Access Compliance Report

Public Rights-of-Way

(Curb Ramps)

Intersection ID: 45503	Main Street: CAPTAIN_ARDREY_RD	Cross Street: COTTON_STAND_RD	Location:	N
ADA ID: 1D581DD328FC	Ramp Type: Perp	Initial Pass/Fail: Fail	Overall Compliance: No	Severity Score: 35

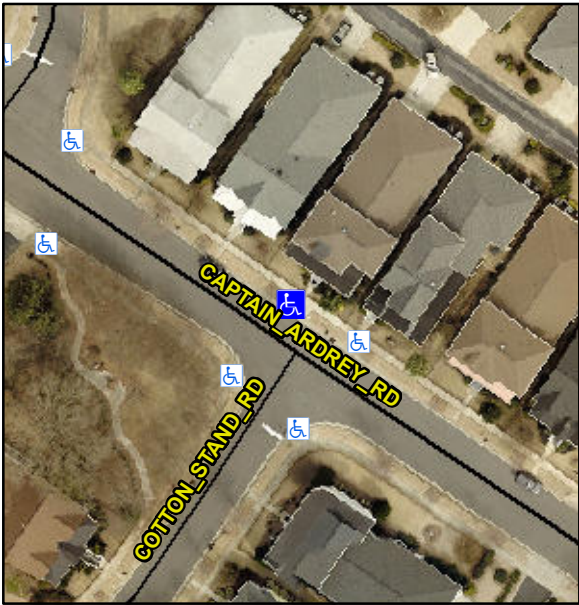
Codes/Mitigation Info/Possible Solution			Field Measurements/Component Compliance					
	Possible Solutions:		Compliance	Description	Data	Compliance	Description	Data
	Remove & Replace Entire Ramp.		N/A	Ramp Length (in)	77.0	No	Ramp Slope (%)	12.6
			No	Ramp Width (in)	44.0	Yes	Ramp XSlope (%)	3.2
			N/A	Flare Type LT	N/A	N/A	Flare Type RT	N/A
			N/A	Flare Slope LT (%)	N/A	N/A	Flare Slope RT (%)	N/A
			N/A	Flare Traversable LT?	N/A	N/A	Flare Traversable RT?	N/A
			N/A	Landing Length (in)	N/A	N/A	DWS Provided?	N/A
			N/A	Landing Width (in)	N/A	N/A	DWS Contrast?	N/A
			N/A	Landing Slope (%)	N/A	N/A	DWS Length (in)	N/A
			N/A	Landing X Slope (%)	N/A	N/A	DWS Full Width?	N/A
Surveyor Notes:		N/A	N/A	Landing Curb? (Y/N)	N/A	N/A	DWS Offset (in)	N/A
PROW/ADA:		Not Found, R304.5.1, R304.2.2	N/A	Shared Landing?	N/A	N/A	Gutter Slope (%)	N/A
			N/A	Gutter Ponding?	N/A	N/A	Gutter X Slope (%)	N/A
			N/A	Gutter Lip Ht (in)	N/A	N/A	Gutter X Slope (%)	N/A

N/A	Painted X Walk1?	No	N/A	Painted X Walk2?	N/A
				X Walk 1 Direction	To SW		X Walk 2 Direction	N/A
			N/A	X Walk 1 Width (in)	N/A	N/A	X Walk 2 Width (in)	N/A
				X Walk 1 Slope (%)	3.5		X Walk 2 Slope (%)	N/A
				X Walk 1 X Slope (%)	3.3		X Walk 2 X Slope (%)	N/A
			N/A	Ramp inside XWalk1?	N/A	N/A	Ramp inside XWalk2?	N/A
				Road Slope (%)	N/A	N/A	Clear Space?	N/A
				Road X Slope (%)	N/A	N/A	Clear Space to XWalk (in)	N/A
			N/A	Any Obstructions?	N/A	N/A	Storm Grate/Utility Hazard?	N/A
				Obstruction Type			Storm Grate/Utility Type	
					N/A			N/A
						Yes	Surface Condition? (G/P)	Good
Total Cost:		\$ 1850.00
